REMARKS

Reconsideration of the instant application is respectfully requested. The present amendment is responsive to the Office Action of May 28, 2003, in which claims 1-31 are presently pending. Of those, claims 1-5, 7-11, 13-17, 19-23 and 25-30 have been rejected under 35 U.S.C. §102(b) as being anticipated by U.S. Patent 5,114,240 to Mehdizadeh, et al. In addition, the remaining claims 6, 12, 18, 24 and 31 have been rejected under 35 U.S.C. §103(a) as being unpatentable over Mehdizadeh, in view of U.S. Patent 6,522,140 to Harvey. For the following reasons, however, it is respectfully submitted that the application is now in condition for allowance.

FIG. 2 PRIOR ART

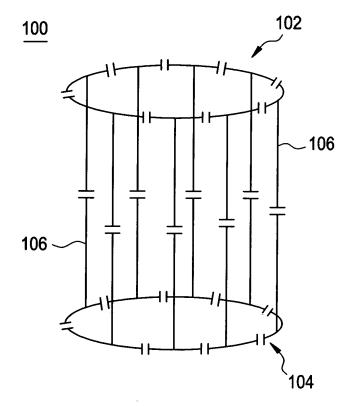
Figures 1 and 2 have been amended as indicated above to include the legend -- Prior Art--. Accordingly, it is respectfully requested that the objections to the drawings be withdrawn.
